## ValveKing Hum Reduction Modification

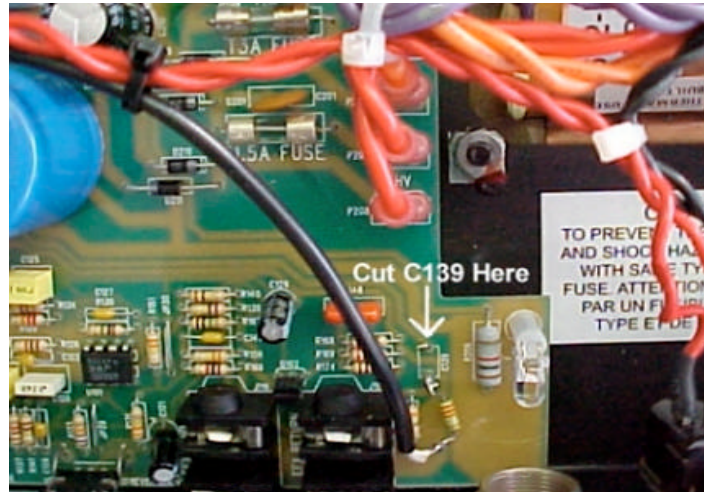
Cut C139 on the side pointed towards the rear of the amp, leaving as much of the lead intact as possible.

Solder a 1C shielded cable to the exposed side of C139 (see picture) and ground the shield, as shown.

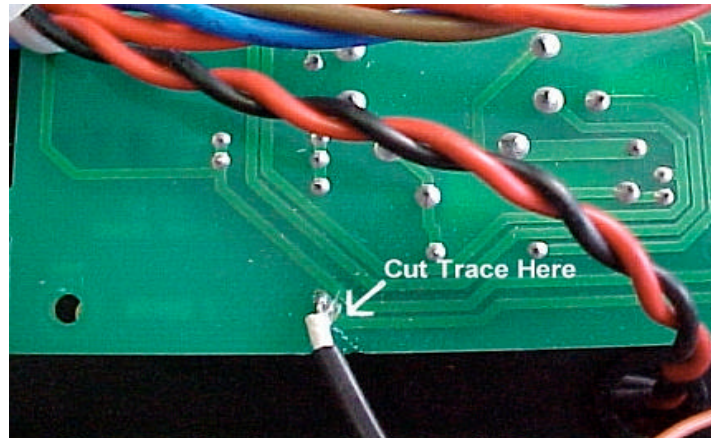
Cut signal trace to C140/R157/V3, pin 2 on power amp just before reaches any components.

Solder the other end of the shielded cable (see picture for length) to C140/R157/V3, pin 2.

Remove the shield from the cable on the power amp side.
